**THE CITY OF THE VILLAGE OF DOUGLAS  
PLANNING COMMISSION  
THURSDAY, FEBRUARY 08, 2024 AT 7:00 PM  
86 W CENTER ST., DOUGLAS MI**

**RE:** 111 Wall St. Special Land Use – Residential Use of an Accessory Building

Thomas and Liana Allison, property owners, have submitted an application for Special Land Use review for the Residential Use of an Accessory Building, per Section. 26.31 of the City of the Village of Douglas Zoning Ordinance on a parcel of land described as Parcel No. 59-551-005-00, located at 111 Wall Street in the R-3, Neighborhood Conservation District. The parcel is also described as lot 5 of Spencer's Addition plat. The subject parcel is generally located on the south side of an unimproved section of the west end of Wall Street, just west of the Wall Street / Union Street intersection.

**Floor Plans**

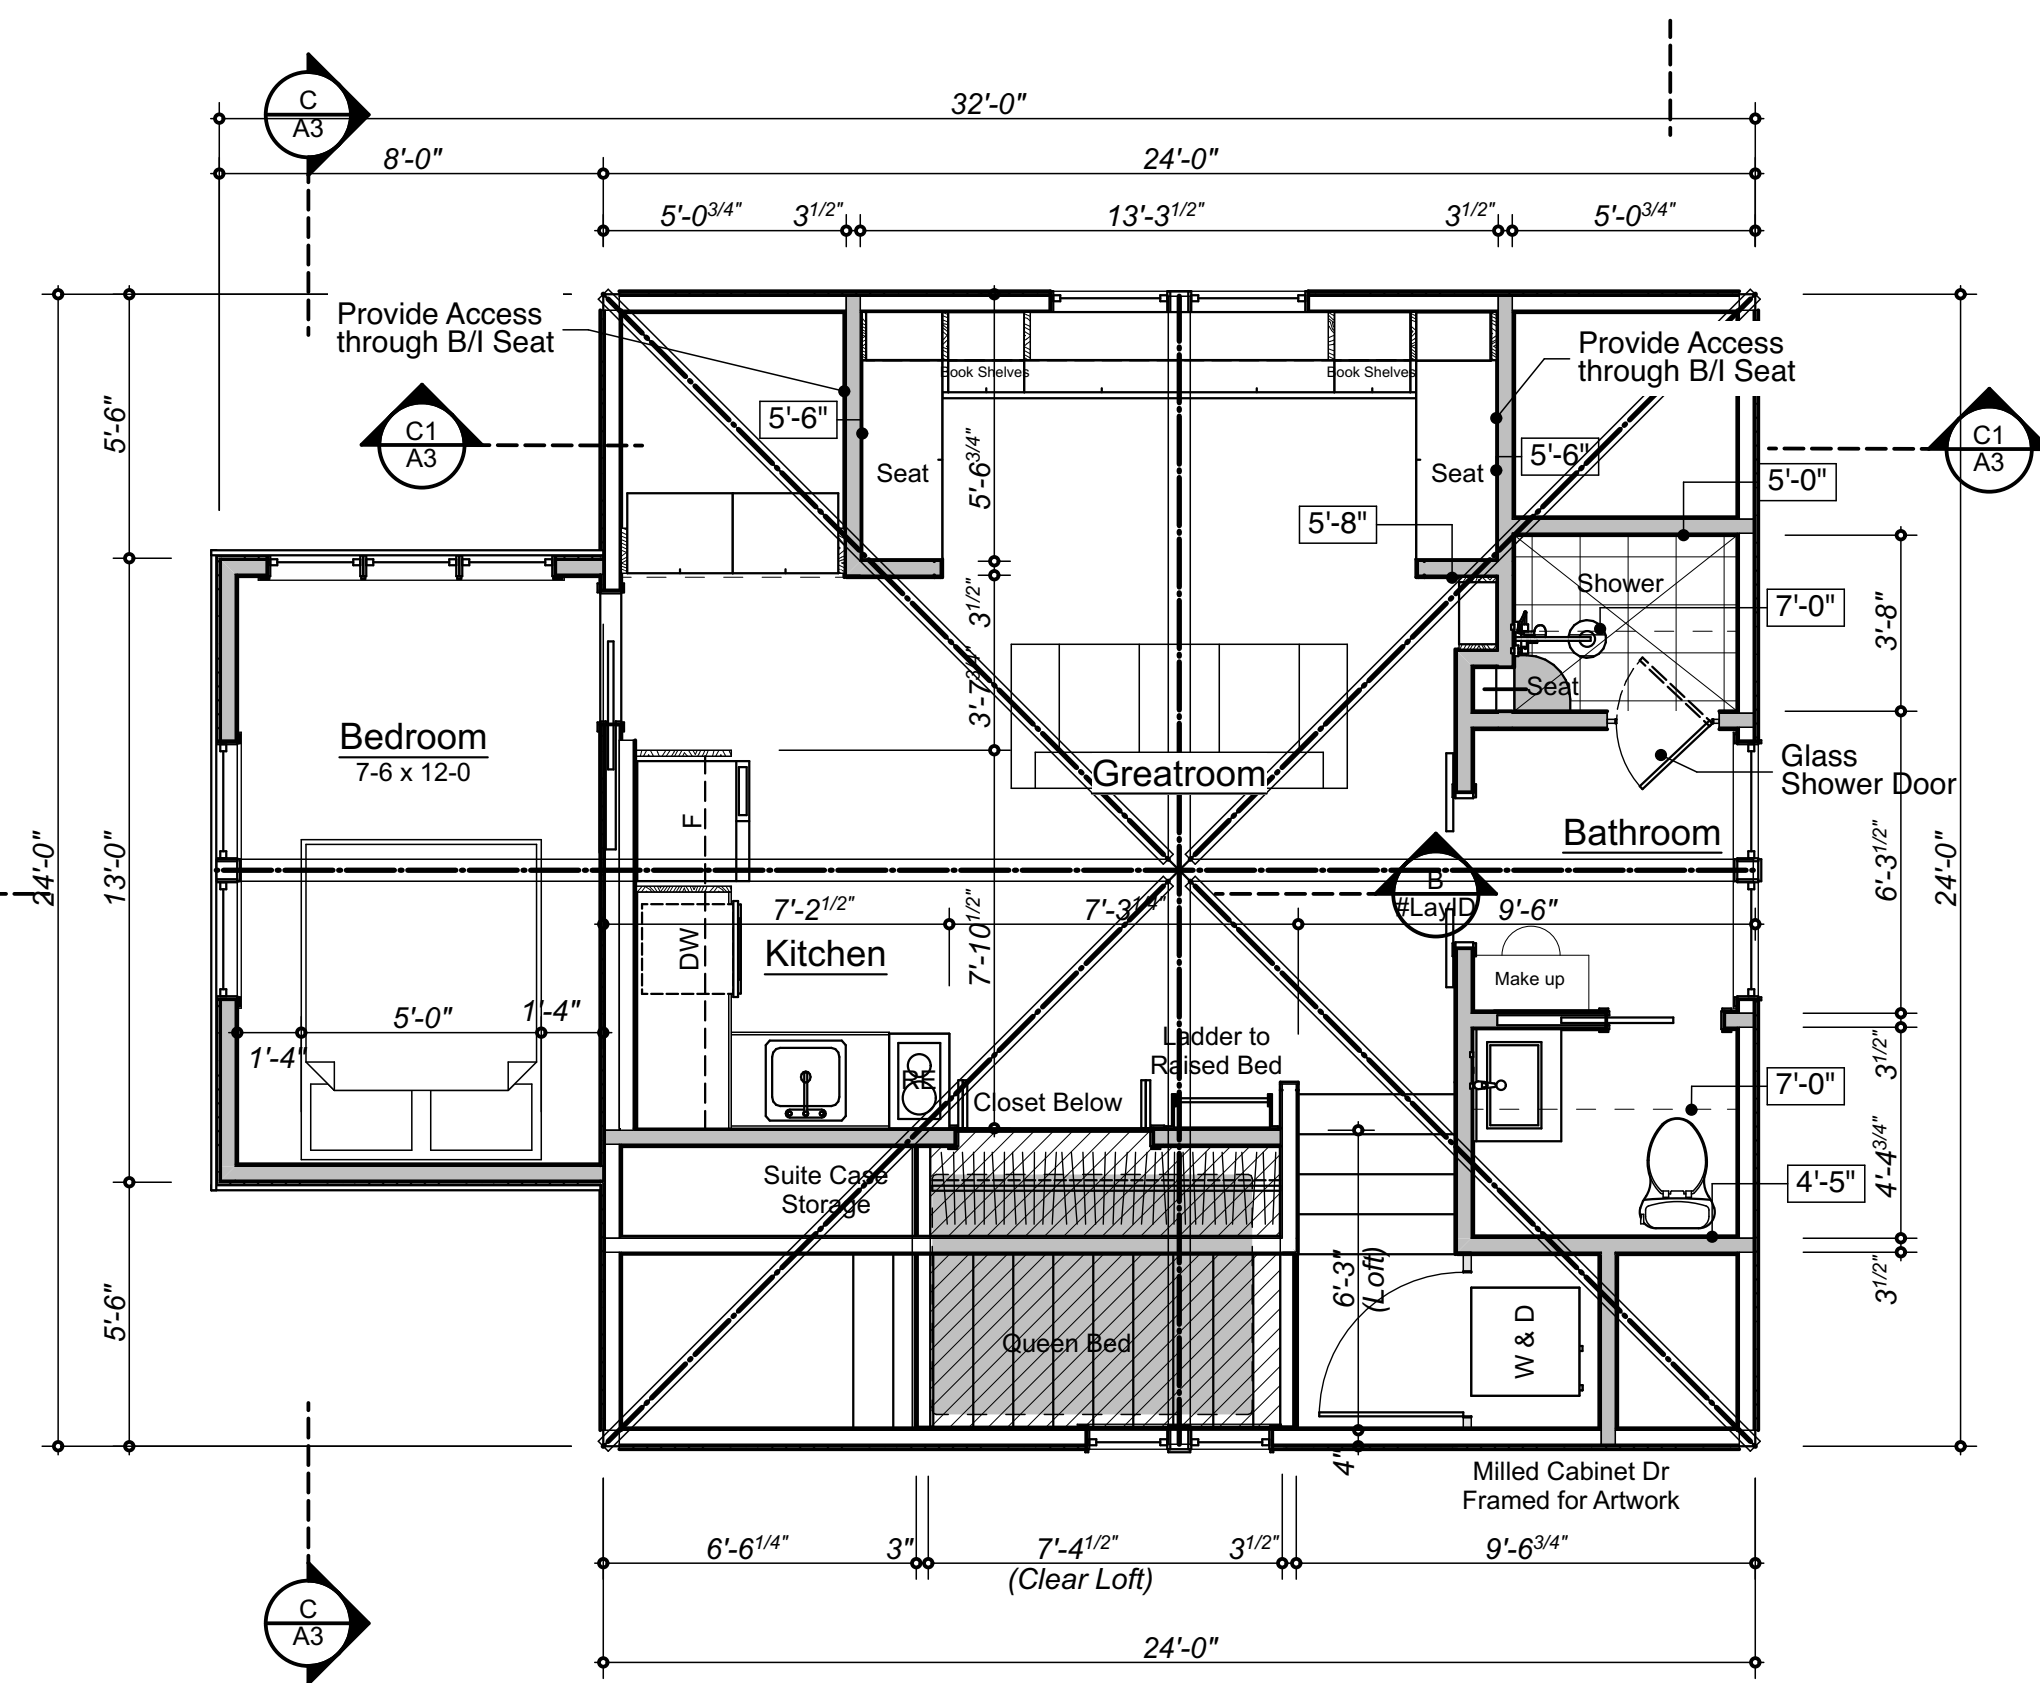
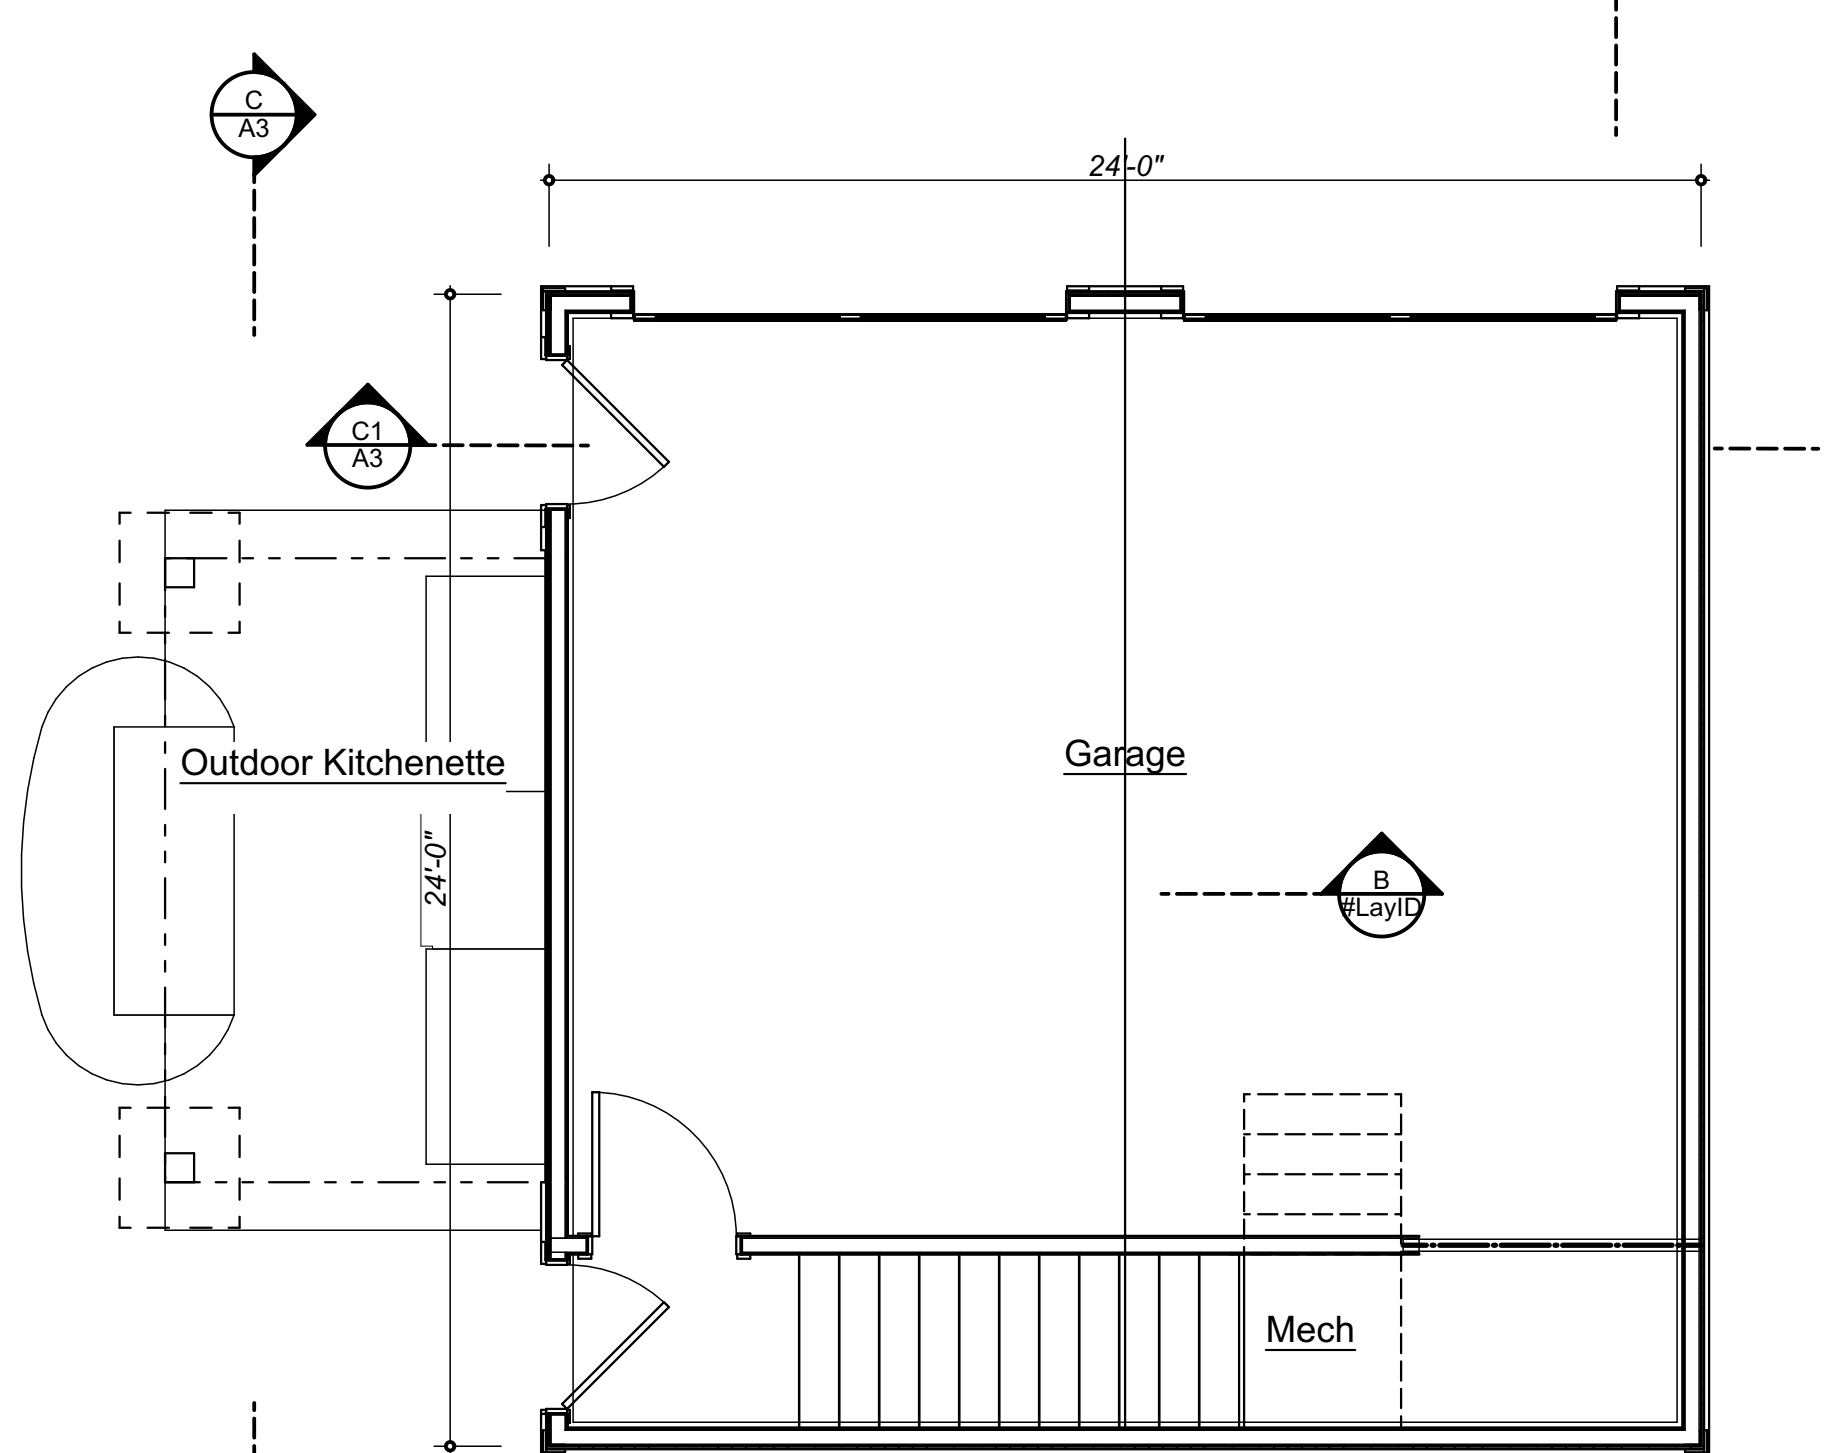
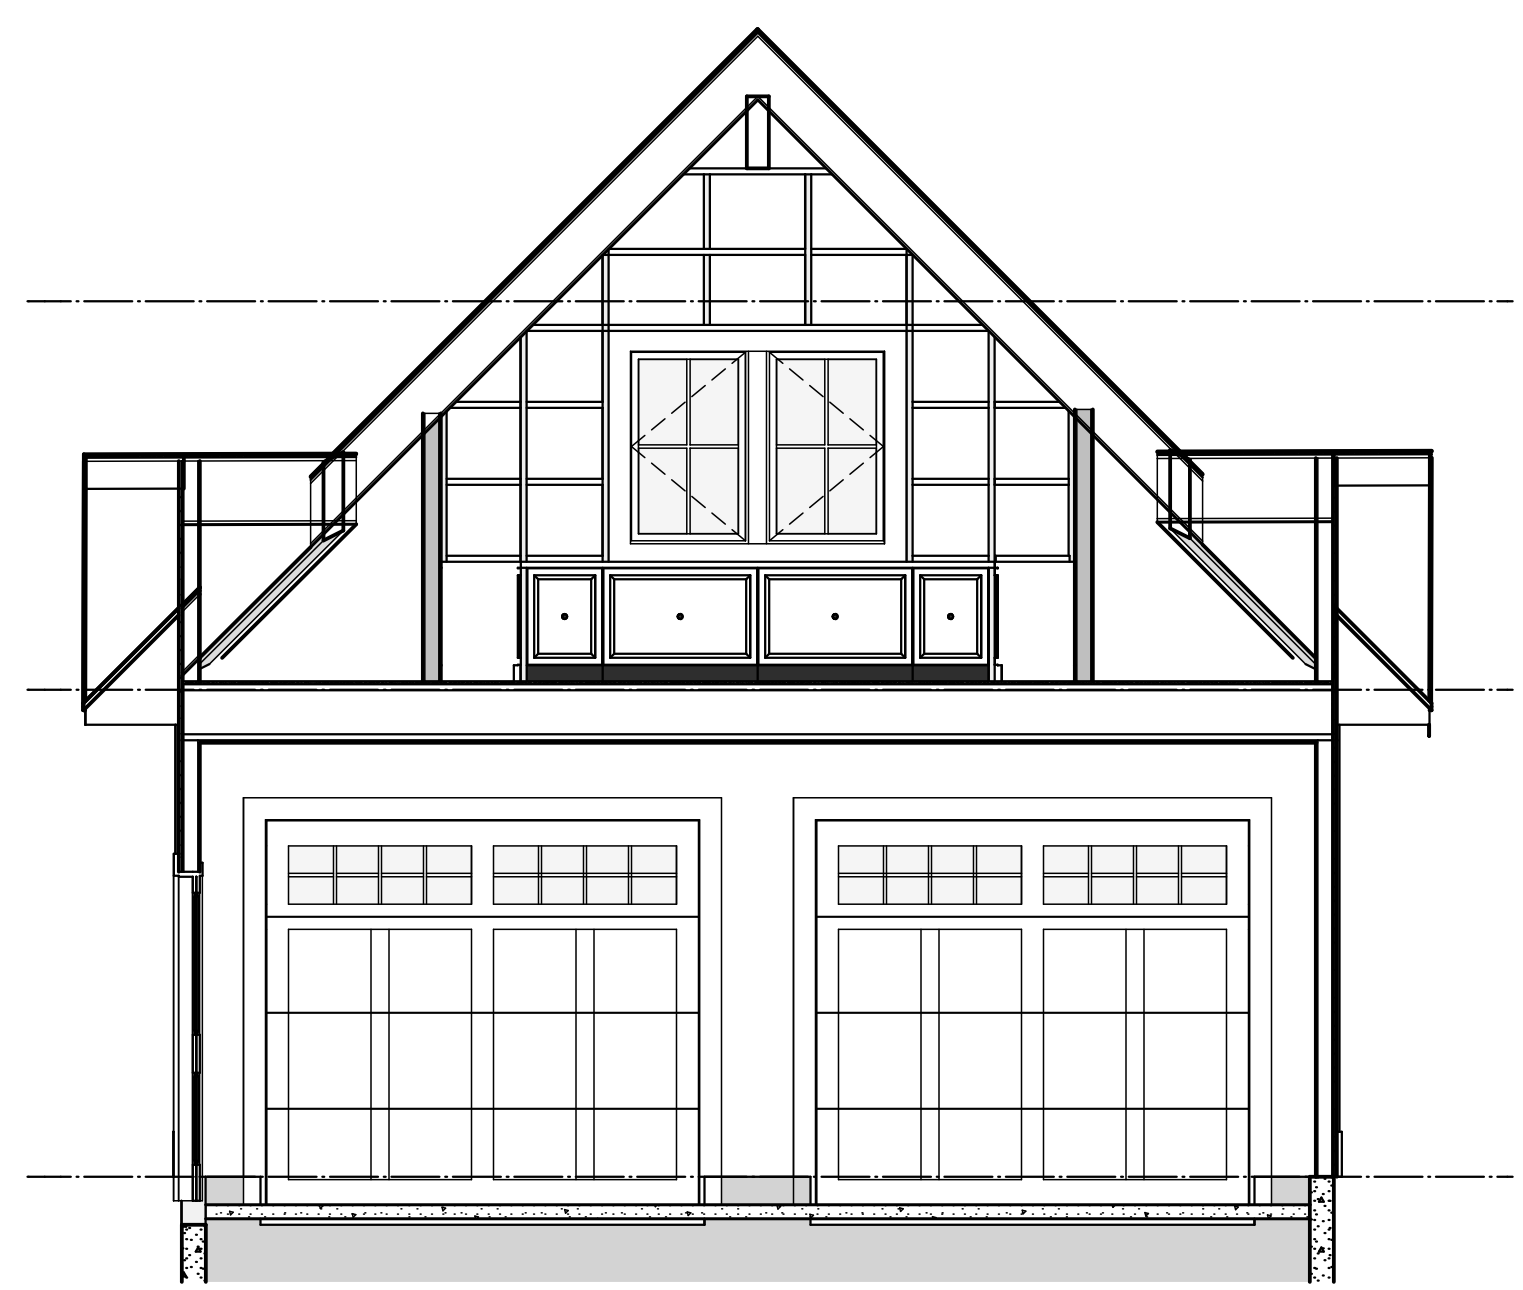
**Comment:** The proposed residential use is proposed on the second story of an existing accessory building. The principal building is 1,805 square feet and the proposed residential area within the existing accessory building would be 680 square feet. The square footage dedicated to half the principal structure is 902.5 square feet. Thus, this requirement is met.

**Comment:** The main floor of the garage is 576 SF and the second level is 680 SF. This requirement is met.
